From: Jill Bastow
Sent: 20 April 2016 14:20
To: Planning
Subject: FW: NYM/2016/0168/FL Seascape, Robin Hoods Bay
Attachments: SKS 04A.pdf

PROJECT
 REPLACEMENT FRONT DORMER WINDOWS, NEW
 REAR ROOF TERRACE AND GARDEN RAILINGS
 for

Mr & Mrs MURPHY
 at
 SEASCAPE, KING STREET, ROBIN HOODS BAY

TITLE
 PROPOSED ELEVATIONS

SCALE	DATE	DRAWING No	REVISION
1:100 @A3	Feb 2016	SKS 04	A

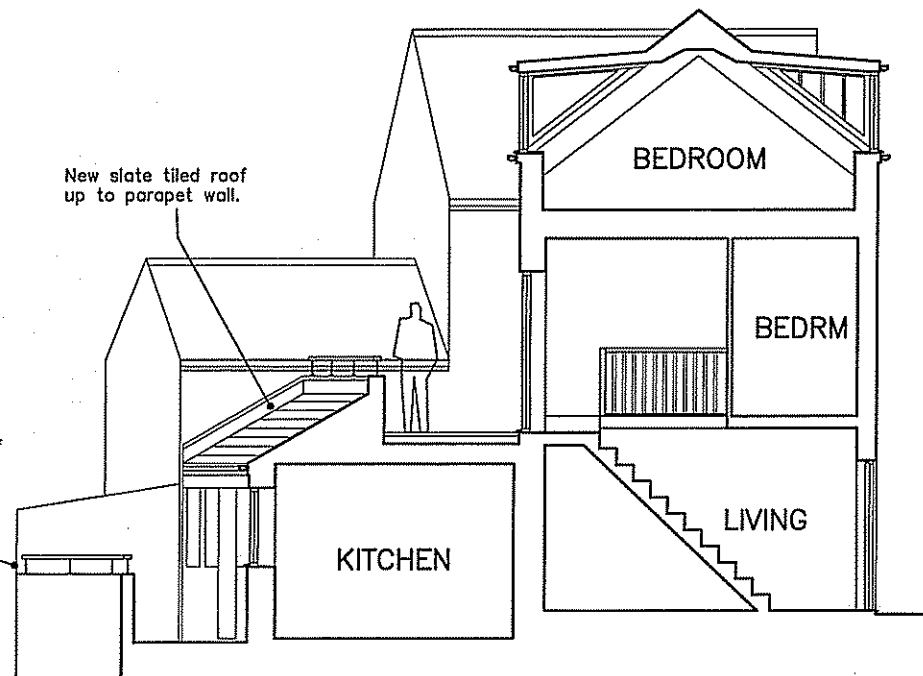
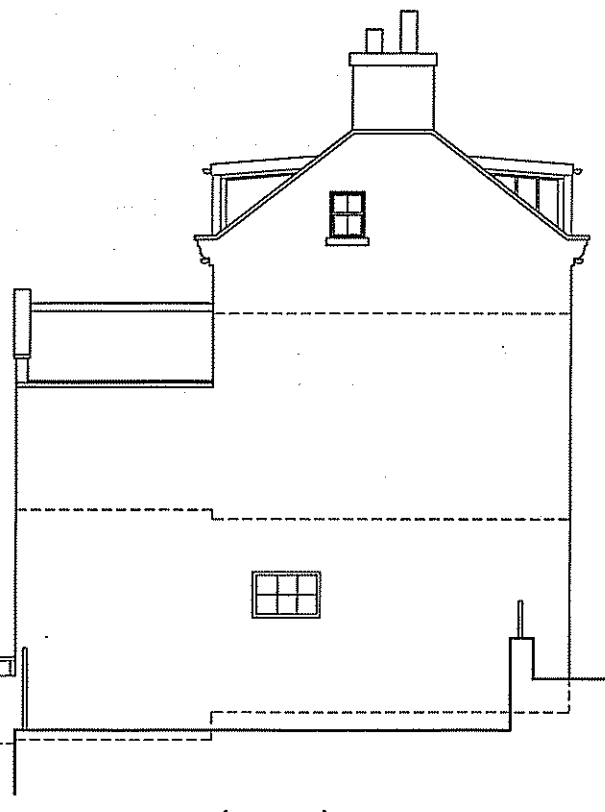
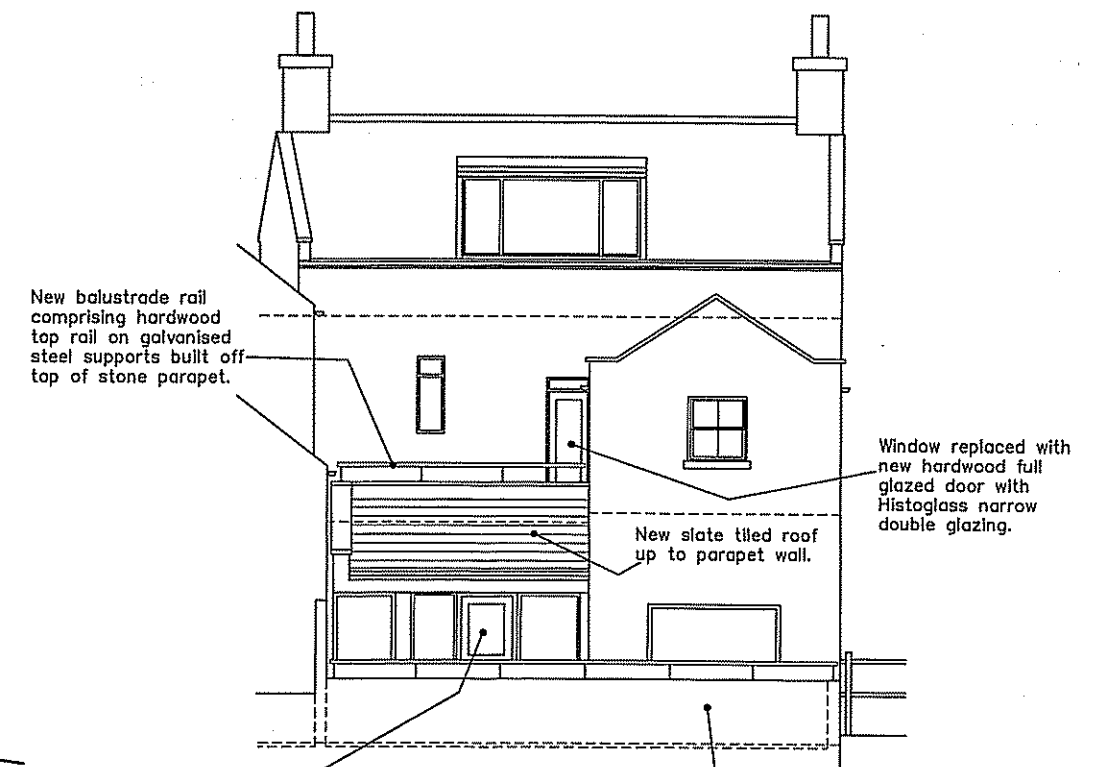
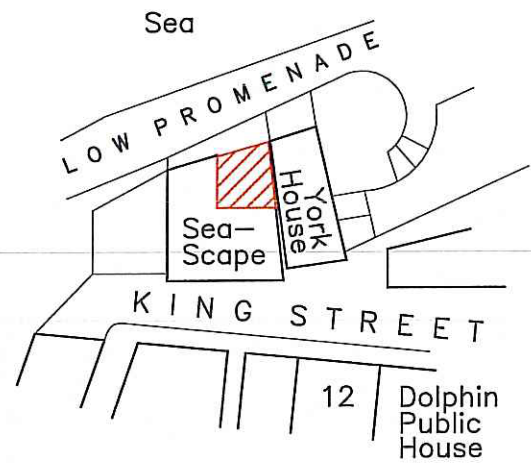
Many thanks for the amended plans Rob. However before I send them off form re-consultation I note that the proposed glass balustrade to the patio is still shown on the elevation drawing. I would be grateful if you could let me have a duly amended plan at your earliest convenience showing the proposed stone boundary wall and timber rail.

A. ROOF TERRACE AND BOUNDARY WALL ALTERED. 18.04.2016

please find attached amended copy of drawing.

The glass and stainless steel balustrading has been removed from the scheme. The roof terrace has been reduced in size and pulled back from the edge of the kitchen roof to avoid any overlooking. The roof terrace is now to be hidden behind a slate tiled mansard roof to the kitchen with a stone parapet wall with a hardwood rail to the top supported on short galvanised steel posts/brackets. There is to be a stone upstand to the open edge of the tiling with a stone capping to reflect the main house roof.

The boundary wall to the patio has also had the glass and stainless steel balustrading removed, to be replaced by a stone wall with the same timber rail with galvanised support brackets on top. The existing wall needs to be raised in height as it is currently too low and dangerous and the timber rail will deter anyone from sitting on top of the wall which is also dangerous as there is a drop the other side.

SCALE	DATE	DRAWING No	REVISION
1:100 @A3	Feb 2016	SKS 03	A

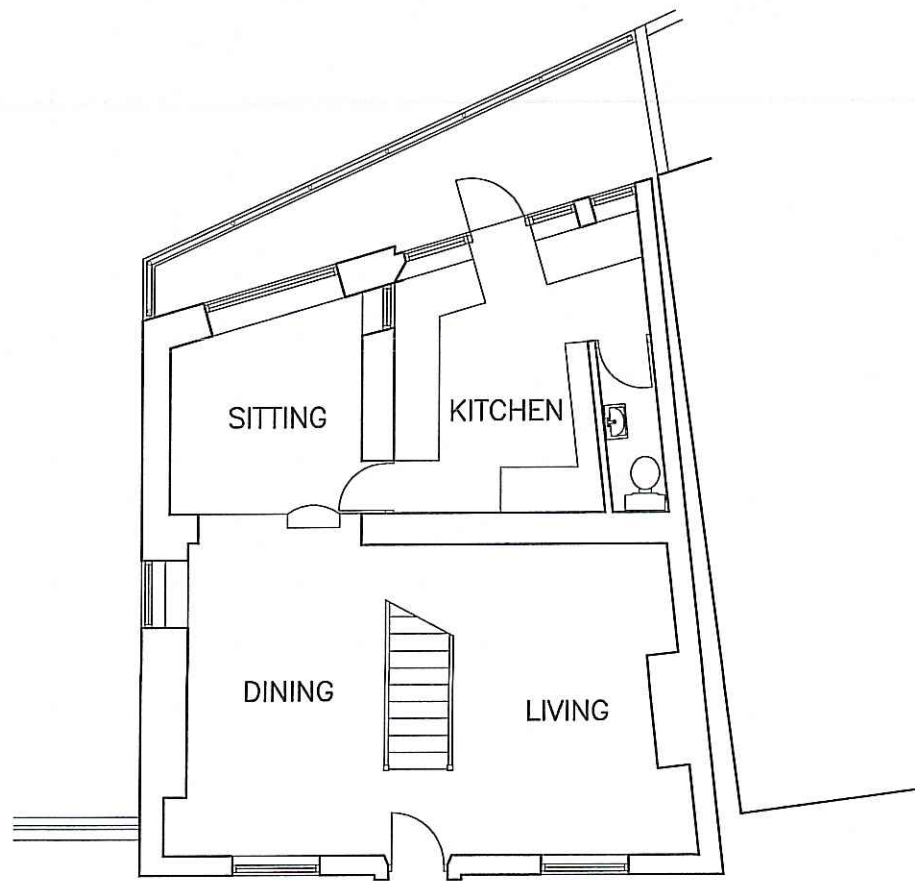
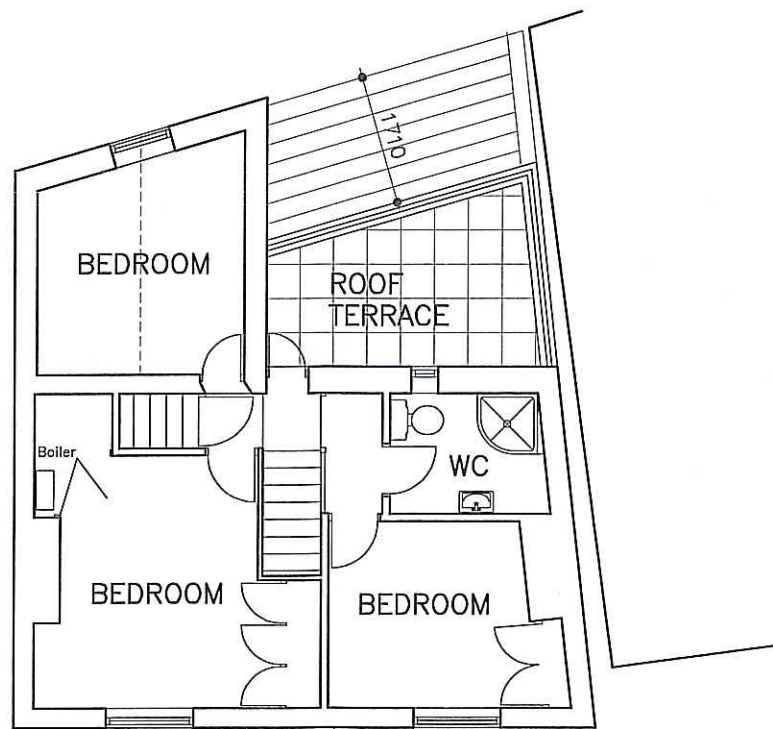
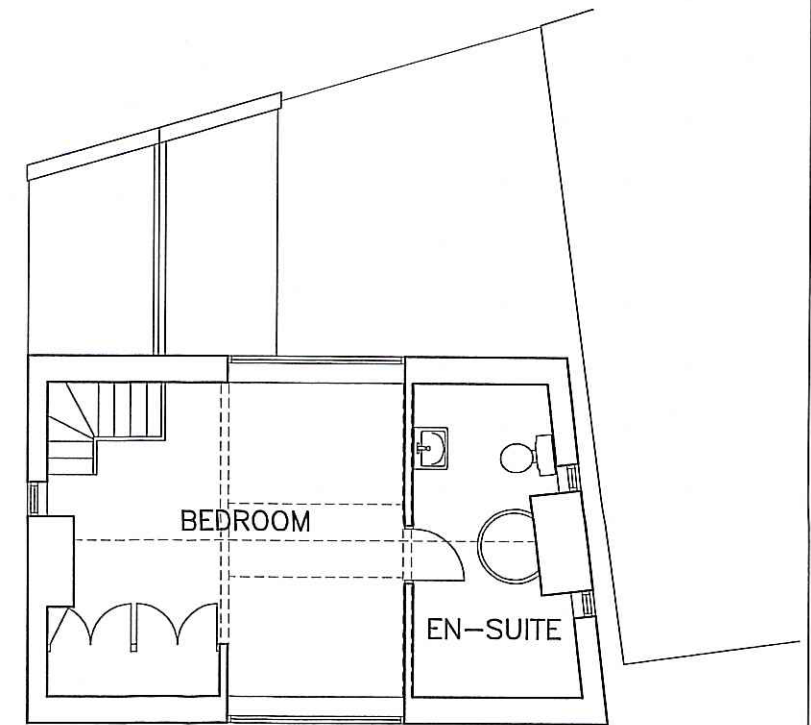
A. ROOF TERRACE AND BOUNDARY WALL ALTERED. 18.04.2016
